HEARINGS REPORT UNDER SECTION 42A OF THE RESOURCE MANAGEMENT ACT 1991 FOR LANDUSE CONSENT APPLICATION LUC24/48512

Applicant:	Bryan & Kim Roach & South Taranaki Trustees Limited
Site Address:	24 and 26 Woolcombe Terrace, New Plymouth
Legal Description:	Part Lot 1 DP 4522 and Part Lot 2 DP 5012 (RT 961499)
Site Area:	904m ²
District Plan Zoning:	Medium Density Residential Zone
District Plan Overlays	Coastal Environment Woolcombe Terrace is a "Local Road"
Proposal	Construction of a new dwelling and associated fencing and retaining walls (retrospective)
Status:	Discretionary Activity under Rule CE-R5 of the Proposed District Plan 2023
Application received:	10th of June 2024
Further Information Requested/Received	4 th July and 14 TH August 2024
Limited notification:	8th of November
Submissions closed:	4th December 2024

Notification Report LUC24/48512: 24 & 26 Woolcombe Terrace.

Figure 2: Site Plan 24/26 Woolcombe Terrace. Source: BOON Architects

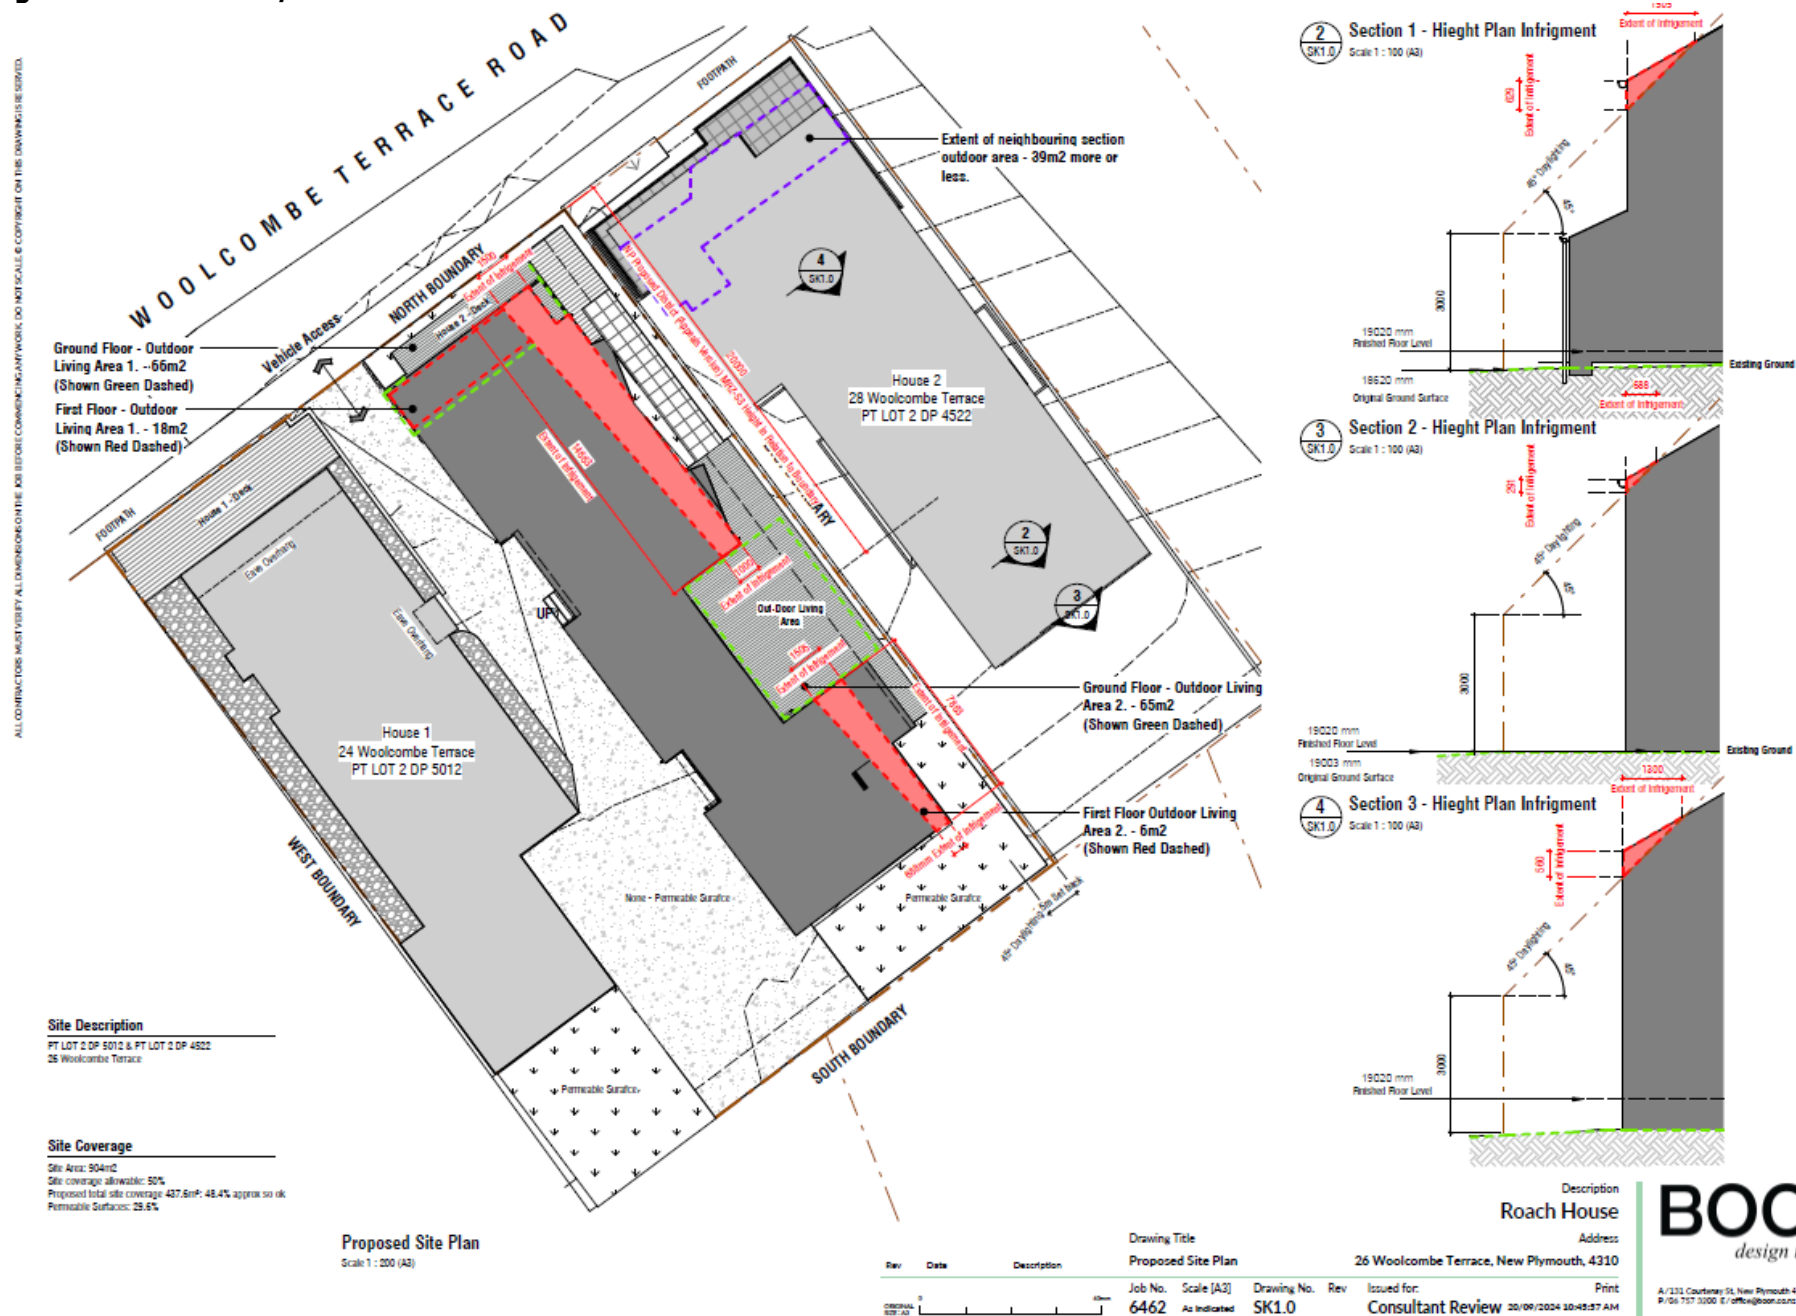
Effects Standard	Effects Standard Name	Complies?	Comment
MRZ-S3	Height in relation to boundary (HIRB)	No	The dwelling fails to comply with the 3m + 45° requirement relative to the boundary with 28 Woolcombe Terrace (refer Figures 2 and 3 ⁶). The area of the infringed by the Standards form is wedged shaped and has a combined length of 29.1m. The breach has a maximum height of 1.9m near the northern elevation of the building.
MRZ-S10	Maximum fence or wall height	No	MRZ-S10 1. outlines that no fences or walls or a combination of these structures whether separate or joined together) within the front yard on "Local Roads" shall exceed 1.4m in height about the existing ground level. The combined height of the as-built wall and glass balustrade would be 2.28m.

Figure 3: Eastern and Northern Elevations. Source: BOON Architects.

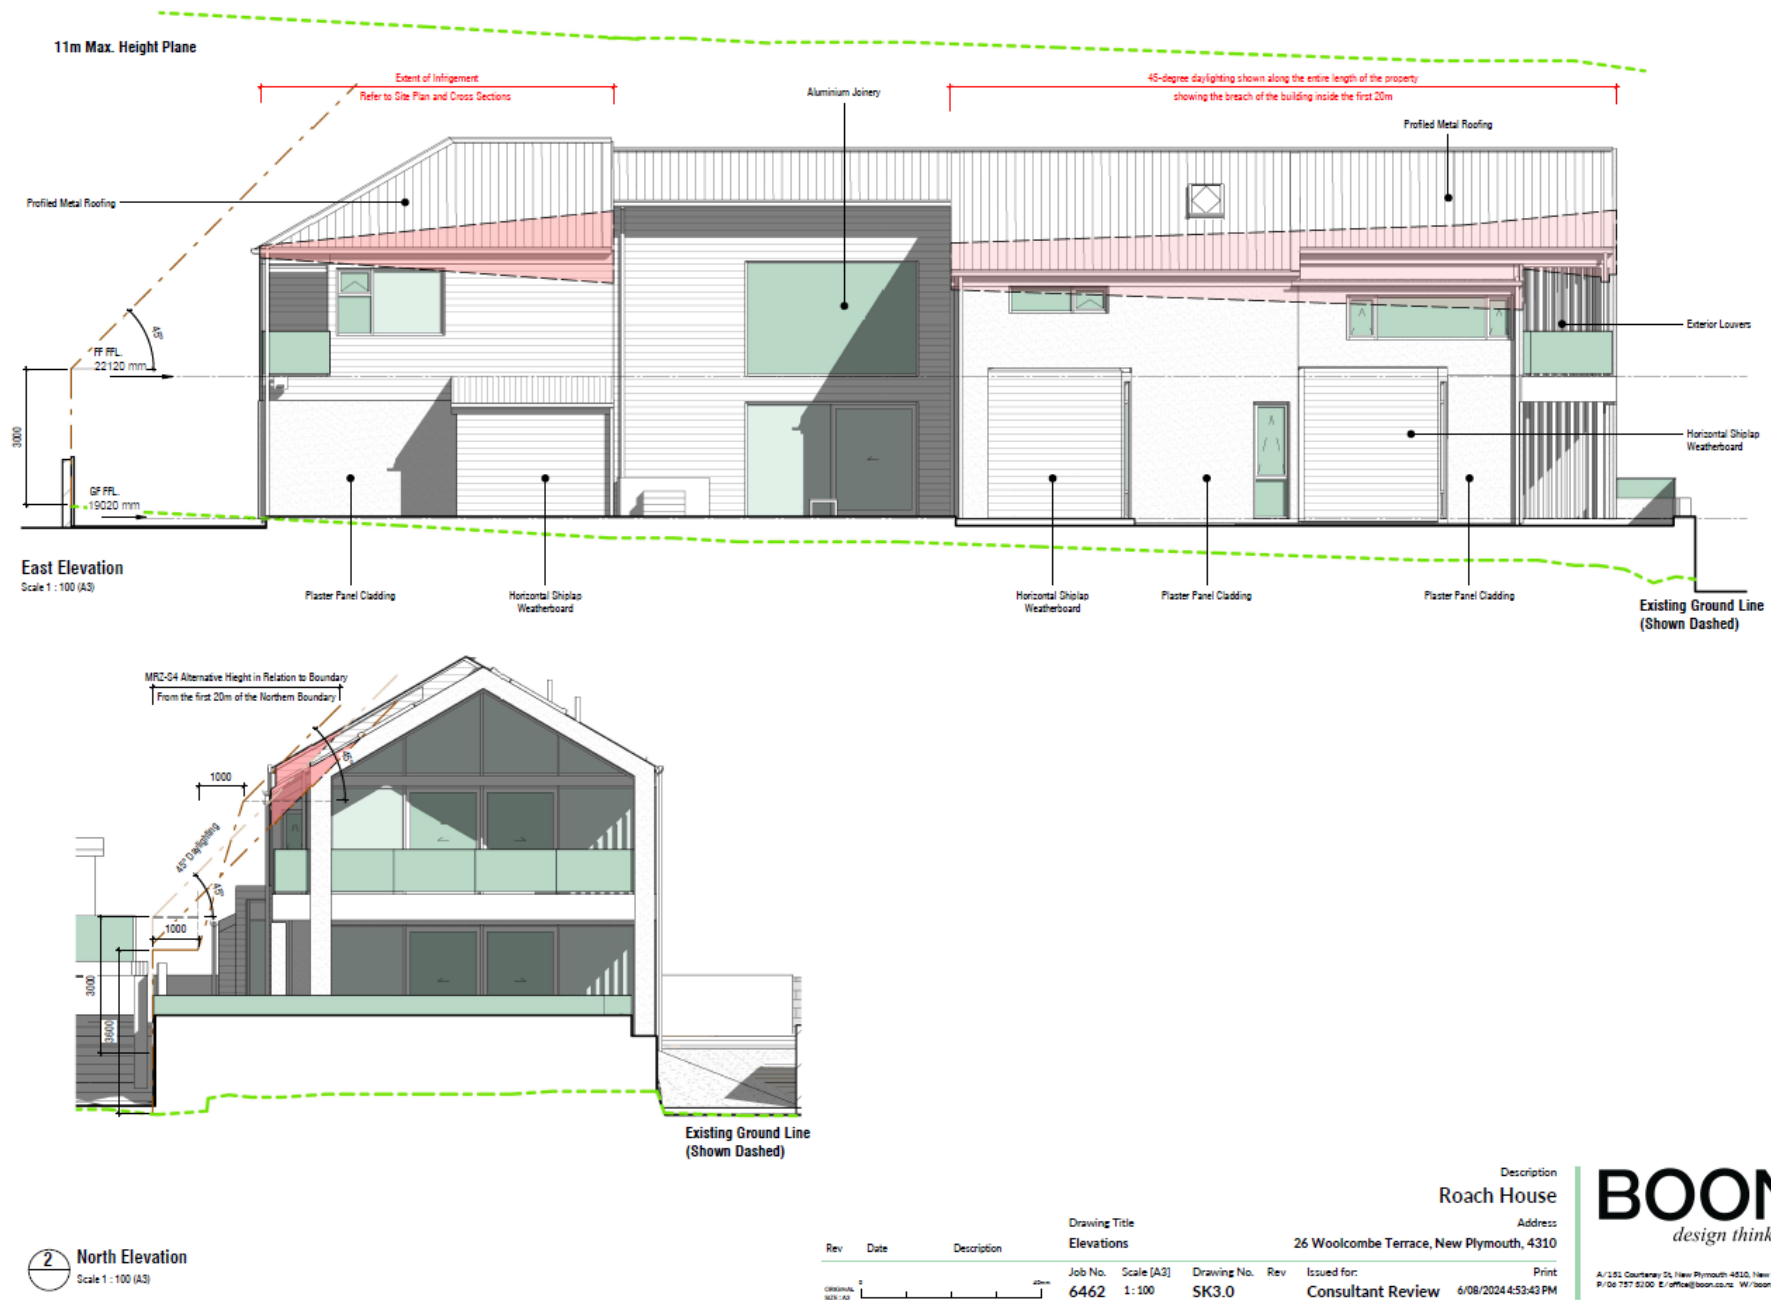
42. The over height wall/balustrade on the street facing boundary would create no clear material adverse effect on the adjoining private boundary with number 28 Woolcombe Terrace. Westerly views from the ground floor private open space area of number 28 are predominantly impeded by an existing solid block wall on the common boundary rather than the front boundary wall (refer

Image 4). Following remedial action, the fence height on the side boundary wall between the properties now complies with the requirements of Effects Standard MRZ-S10.

43. In making my conclusions around the effects of the boundary wall, I have assessed the maximum height of the wall as being 2.28m above the original ground level as shown on BOON drawing SK3.0. This is consistent with the notification report. Given the submitter has raised questions regarding the accuracy of the height, the applicant should:

- clarify the maximum height of the wall; and
- update the front elevation on of drawing SK3.0 to reflect the fact there are no stairs on the common boundary between the application site and 28 Woolcombe Terrace.

Figure 5: Comparison of shading effects 22nd September.

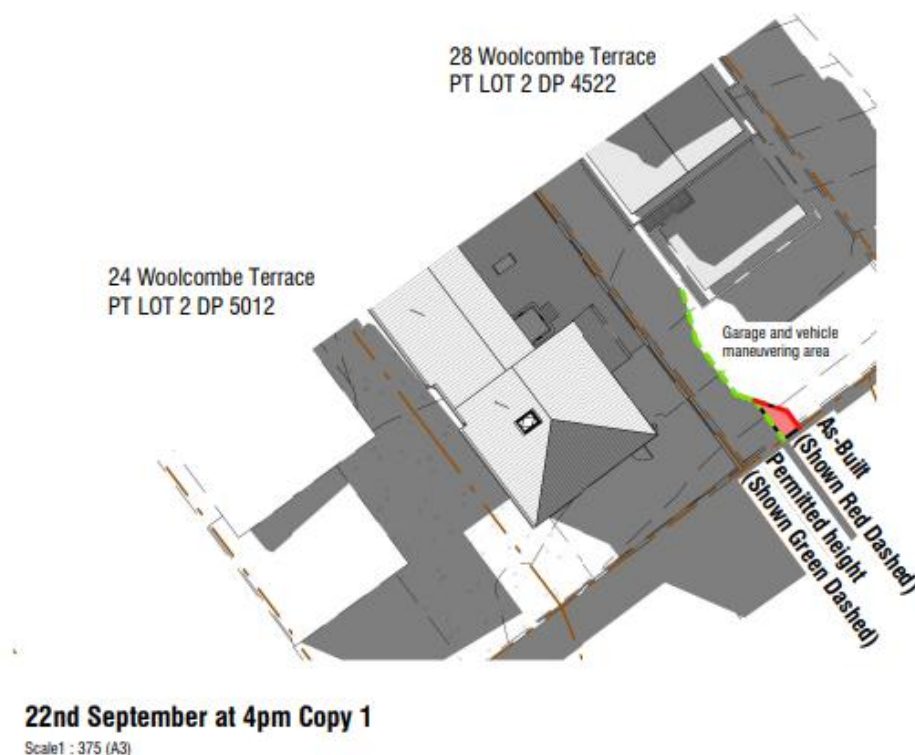
36. The diagrams comparing shading effects on the 22nd of September remain the most relevant as they show the difference in shading effects between a compliant building and the as-built dwelling. As shown in Figure 5, the as-built dwelling would create some additional shading in late afternoon periods over and above a building of the same height which complies with the HIRB Effects Standard MRZ-S3¹¹.

Figure 6: Location of additional shading relative to private outdoor spaces.

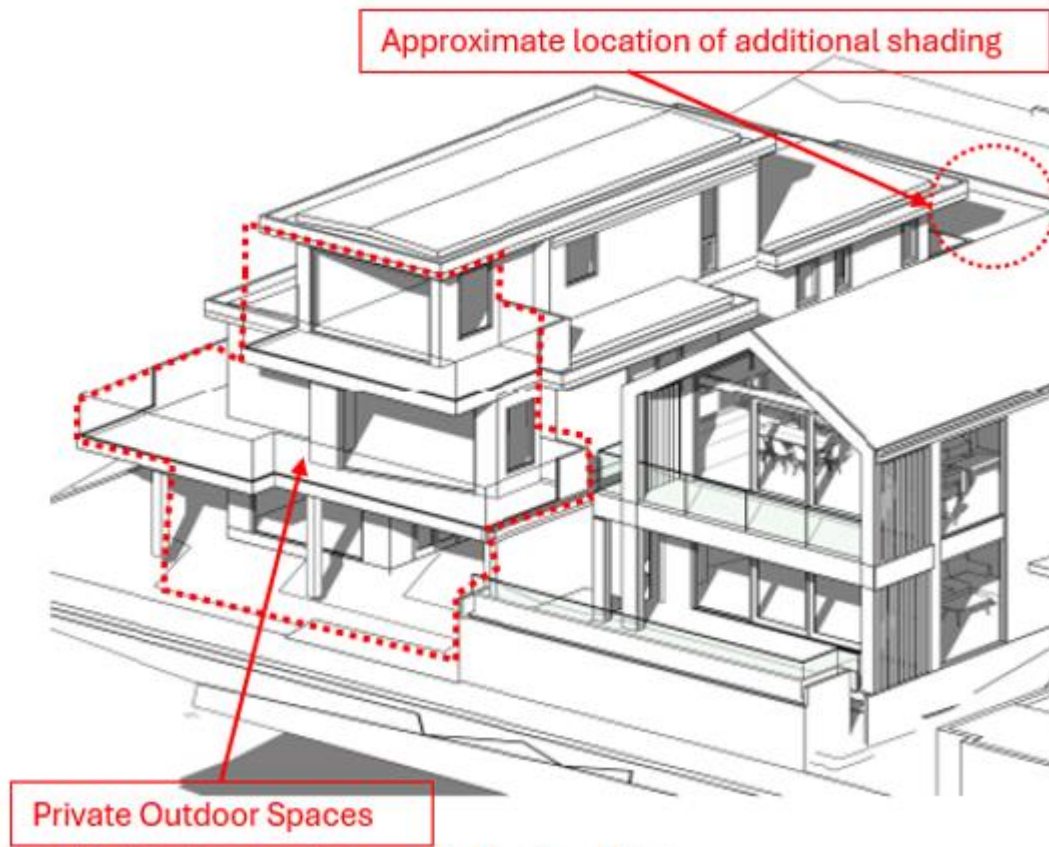
37. The submitter has outlined that area of their site which would be impacted by shading can be used for outdoor amenity purposes and is not, as stated in the notification report, “used in association for parking and manoeuvring”. The area in question is the south-western corner of #28.

38. I accept that there is no impediment for this space being used for amenity but would note from my own observations that the space is one of several private outdoor amenity spaces available to the occupants of the property. Other spaces appear to be more functional and provide higher levels of amenity. For example, the ground floor, first floor and second floor spaces located on the northern elevation are directly adjacent to and accessible from the dwelling and provide long views over the adjacent coastal line. The shading diagrams show that when compared to the permitted baseline scenario, these spaces would not be impacted by the development.

39. Whilst the submitter has raised concerns that the shading diagrams do not accurately reflect the possible shading effects, in the absence of any further technical evidence, I have no clear reason to not accept the accuracy of the offered analysis.
40. Overall, I consider shading effects are less than minor and ultimately acceptable. Whilst the development does create some additional shading over and above a building which complies with the HIRB standards, the shading is marginal in terms of its area and the time in which it would occur. Consistent with my notification assessment I consider that the area of the site affected by additional shading over and above the permitted baseline is less sensitive to additional shading when compared to other private outdoor spaces.

Figure 7: First floor decking areas – 26 Woolcombe Terrace.

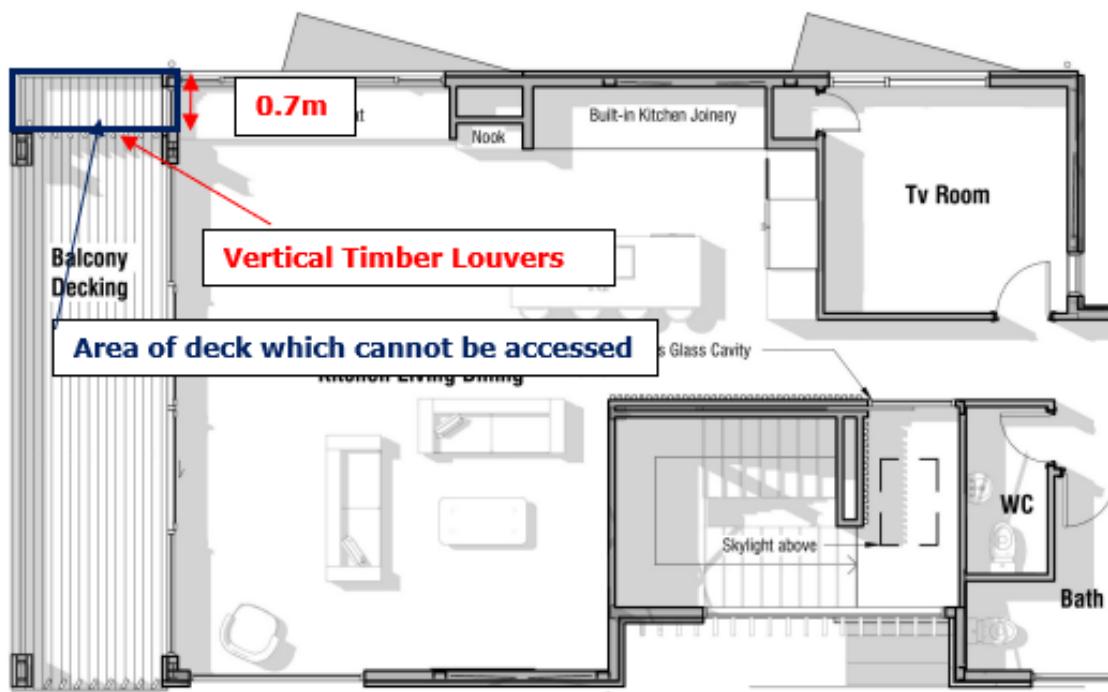
- Compliance with Effects Standard MRZ-S5 3. will be achieved by installing vertical timber louvers to the eastern edge of the terrace. A condition of consent is recommended to this effect. Once installed, any overlooking or privacy effects that do result would be consistent with effects of the permitted baseline (refer Figure 7).

Figure 6: Comparison of shading effects 22nd September.

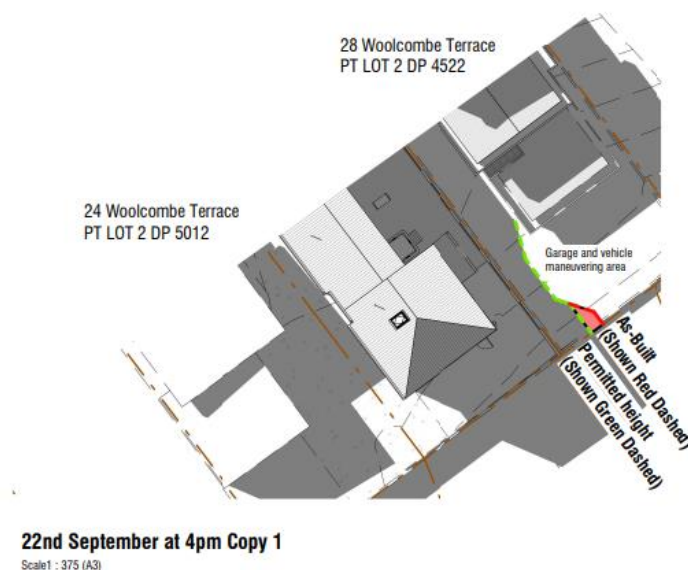
42. From the analysis provided, the diagrams comparing shading effects on the 22nd of September are the most relevant as this shows a clear different between an anticipated building and the as-built dwelling. As shown in Figure 6 below, the as-built dwelling would create some additional shading in late afternoon periods over and above a building of the same height which complies with the HIRB Effects Standard MRZ-S3⁸.

Figure 7: Location of additional shading relative to private outdoor spaces.

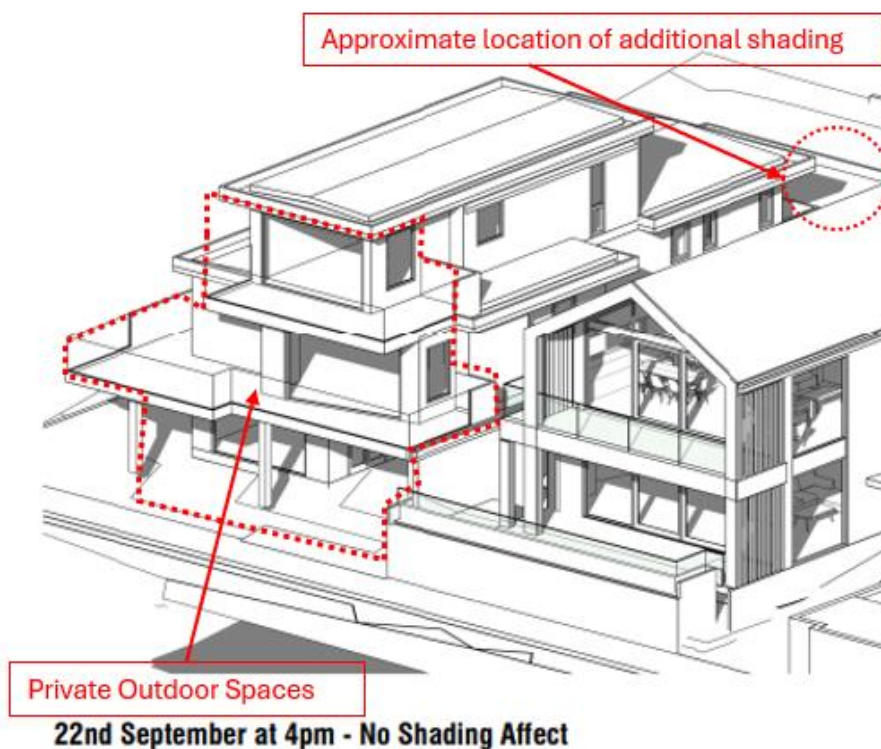
43. The area of number 28 which would be impacted by the additional shading is an area of hardstanding used in association for parking and manoeuvring located in the south-western corner of the site. The additional shading created does not appear to fall upon on the existing dwelling itself or any of its private outdoor spaces located at ground, first and second floor on the northern elevation (refer Figure 7).

44. Overall, I agree with the analysis put forward in the application that shading effects are less than minor. Whilst the development does create some additional shading over and above a building which complies with the HIRB standards, the shading is marginal in terms of its area and the time in which it would occur. Moreover, the area of the site affected is not particularly sensitive to additional shading.
45. I would have likely reached a different conclusion on shading effects if any additional shading created by the proposal had materially impacted the private outdoor spaces or internal living spaces of the adjoining dwelling.

Figure 8: First floor decking areas – 26 Woolcombe Terrace.

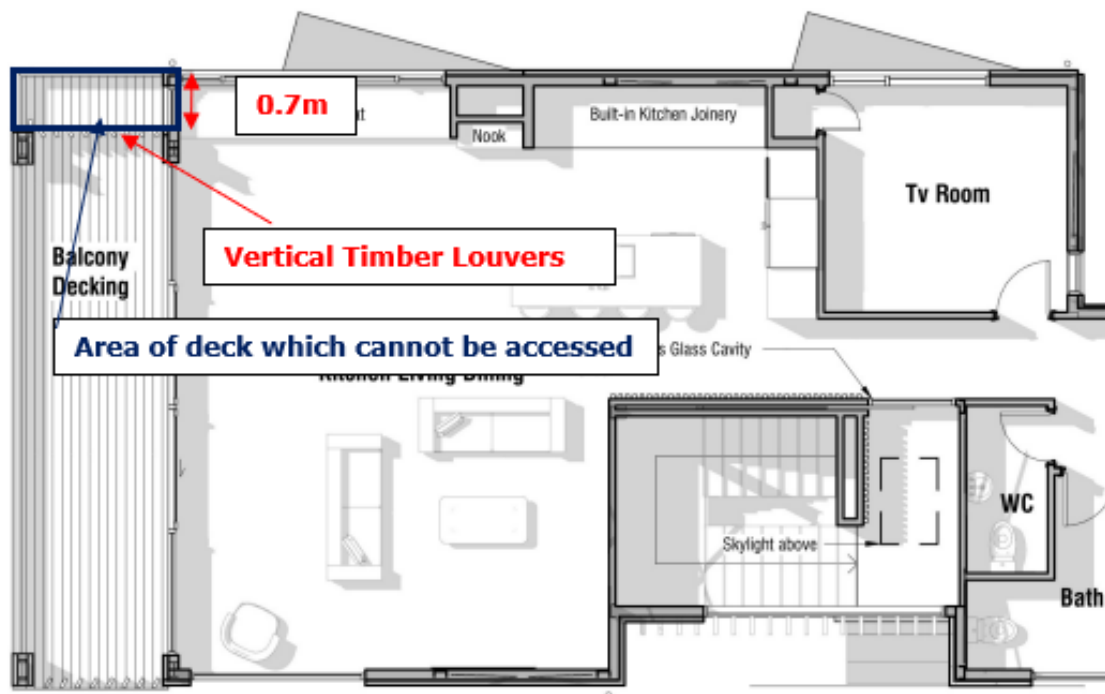
- Access to the area of the first-floor deck which fails to comply with MRZ-S3 is blocked by vertical timber louvers set-back 0.7m from the edge of the building. The placement of the louvers effectively avoids any overlooking or privacy loss from this aspect of the infringement (refer Figure 8).
